De-Multiplexer

PROJECT: DecaMux_9	REVISION: 0
DATE: 10-6-2014 22:53:31	SHEET: 1/1

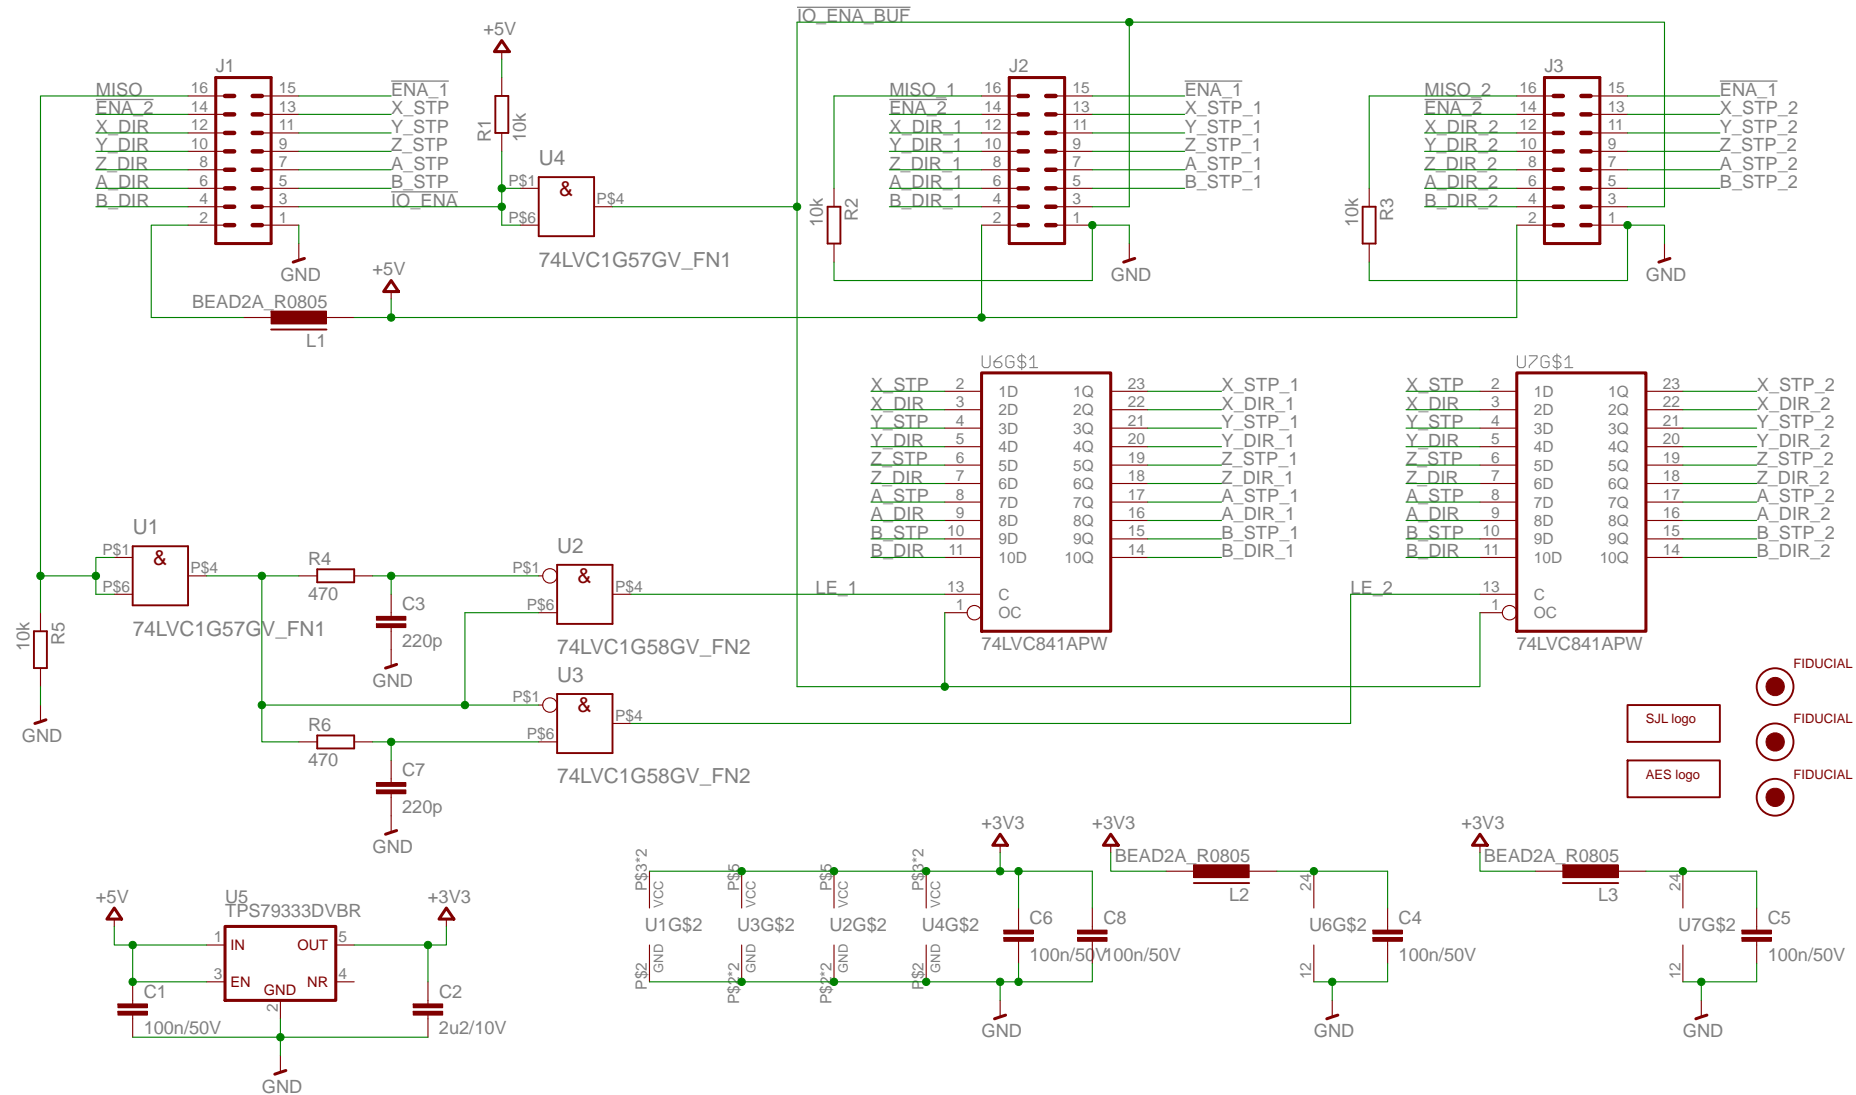
Changes:

- IO_ENA to PEPPER boards no longer open-drain
- Stepper driver levels are now 3.3 Volt instead of 5 Volt
- MISO signals are terminated with 10k to GND
